SUBDIVISION VARIANCE REVIEW SHEET**CASE NO.:** C8-2015-0227.0A**P.C. DATE:** 05-10-16**SUBDIVISION NAME:** 1023 Springdale Subdivision**AREA:** 9.99 acres**LOT(S):** 1**OWNER/APPLICANT:** 1023 Holdings, LLC
(Daryl Kunik)**AGENT:** 1023 Holdings, LLC
(Daryl Kunik)**ADDRESS OF SUBDIVISION:** 1023 SPRINGDALE RD**GRIDS:** ML22**COUNTY:** Travis**WATERSHED:** Boggy Creek**JURISDICTION:** Full Purpose**EXISTING ZONING:** CS-CO-NP**DISTRICT:** 3**NEIGHBORHOOD PLAN:** MLK**PROPOSED LAND USE:** Commercial**ADMINISTRATIVE WAIVERS:** None

VARIANCES: The applicant requests a variance from LDC section 25-4-151 which requires that streets in a new subdivision shall be aligned with and connect to existing streets on adjoining property. The applicant proposes to not extend Don Ann Street into the proposed subdivision.

SUBJECT: 1023 Springdale Subdivision (C8-2015-0227.0A)
Variance of Title 25, Section 25-4-151 (Street Connection)

Figure 1. Plan view of Springdale Addition Plat, 1947.

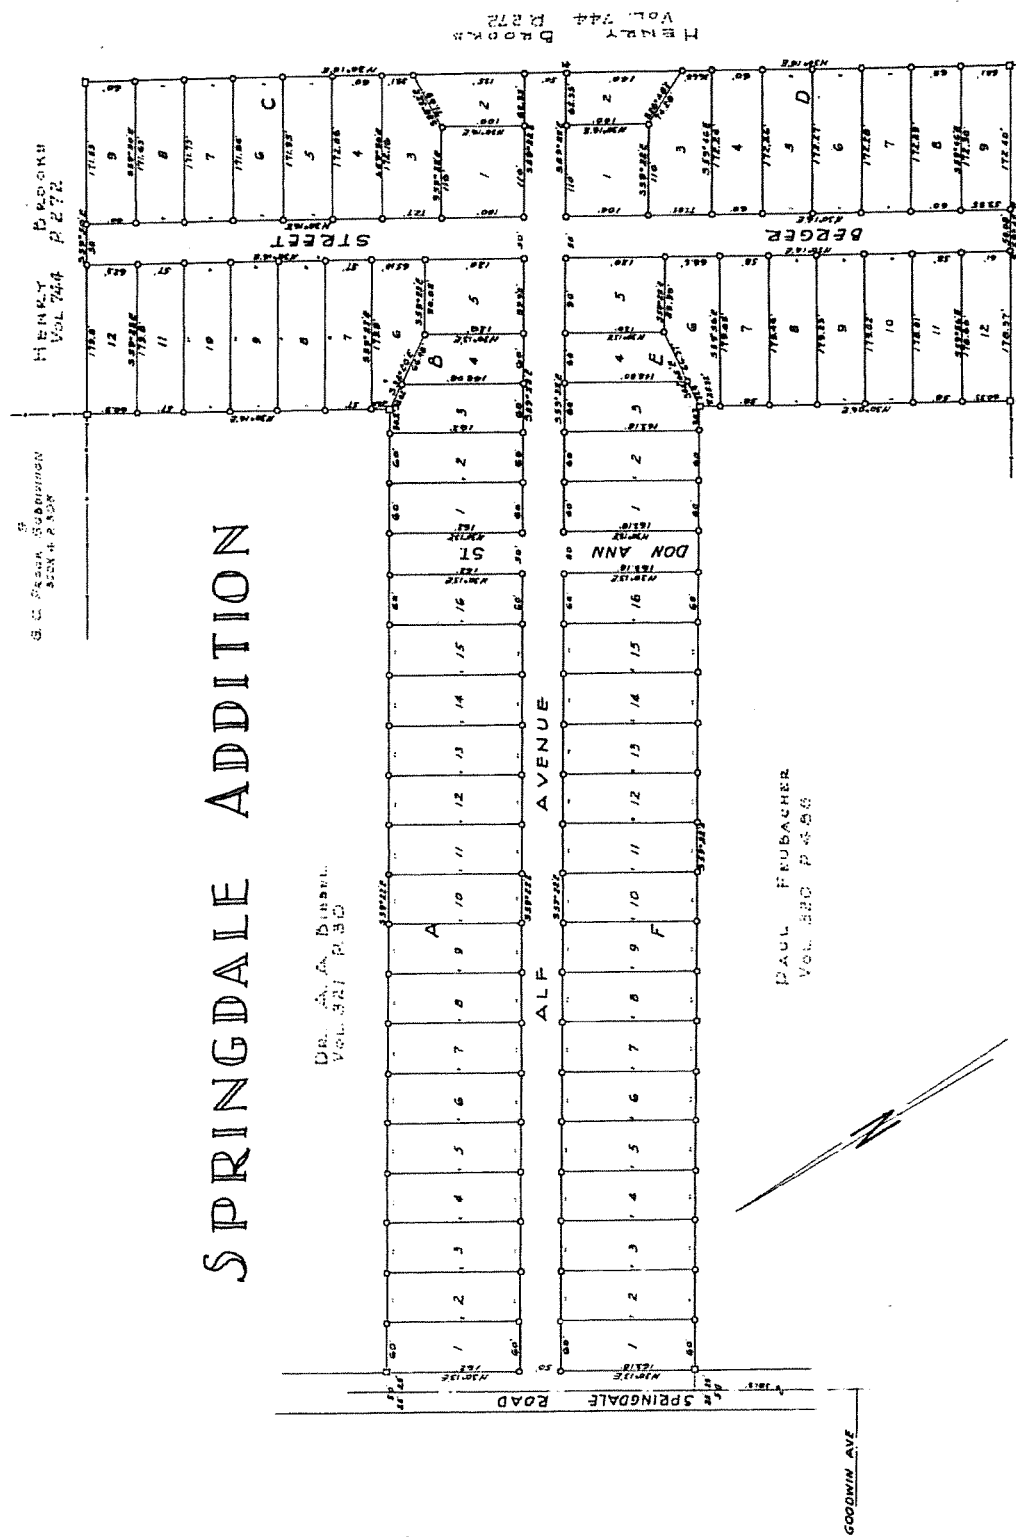
The existing residential property to the north was platted as Springdale Addition in 1947 and is attached as Figure 1 for reference. It included right of way for a future extension of Don Ann Street south of Alf Avenue which extends to the 1023 Springdale site. Although this section of ROW exists, it is not paved or used by vehicles or pedestrians as a connection. Refer to aerial image shown in Figure 2.
